WATER WELL RECORD (WWC5.2)

ZARCO 66

1005 N. PEARL, PAOLA, KANSAS

Zarco #6, 1005 N Pearl, Paola, MI Co, KS
KDHE Project Codes: A4-061-40339/A4-061-40362/A4-061-40431

REMEDIAL SITE SURVEY

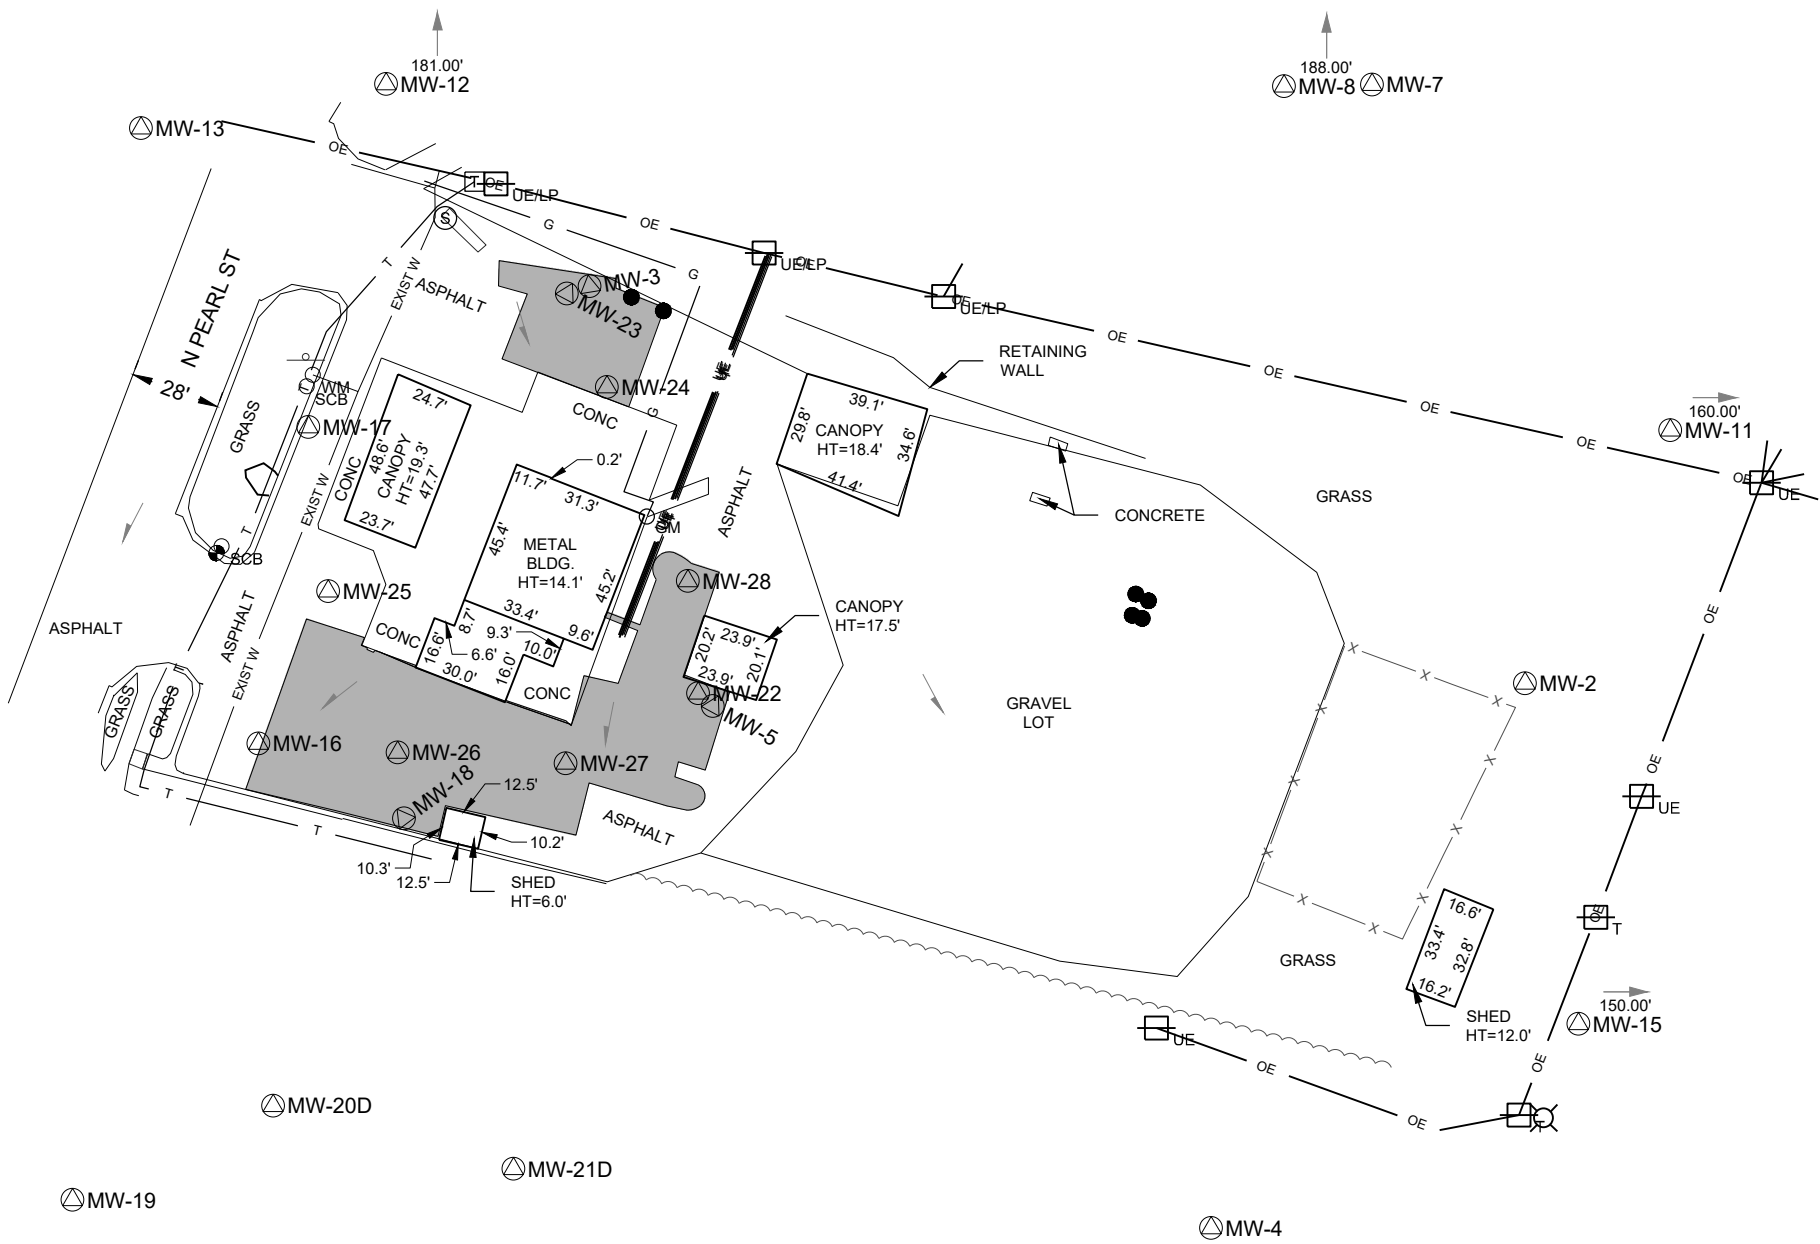
Matt,
In addition to the required lat/long coordinates for each flush-mount well and a site map showing their locations, there is one more condition. Please put the following statement in the **Comments** section (Well Details tab) for each of the six (6) monitoring wells (assuming these will be submitted via KOLAR – if not then in Notes section of the fillable WWC-5 Form):

“When the well is to be plugged, remove all casing & screen then fill with liquid grout (if pulled), or

by over-drilling, then filled with approved grout.”

I would like to request a variance of the five feet grout requirement into the first clay of KAR 28-30-6 (b)(1) for the installation of six monitoring wells at Zarco #6 1005 N. Pearl, Paola.

These wells are being installed to delineate a dissolved phase petroleum plume at a leaking aboveground storage tank site (KDHE Project Codes: A4-061-40339/A4-061-40362/A4-061-40431). Limestone bedrock causing auger refusal is encountered at between four and ten feet across the site. Groundwater, when present, is approximately six feet below ground. Existing wells are often dry.

The proposed wells will be installed with a top of screen at 3’ below ground surface. The screen will extend to where auger refusal occurs. Gravel pack will extend 6” above the top of screen (2.5’ below ground surface). Grout (3/8” bentonite chips) will be placed from 0.5’ to 2.5’ below ground surface. The well will be completed in flush-mount vaults due to traffic in the vicinity.

Consider this email approval of your variance request, conditional upon the above requirements.
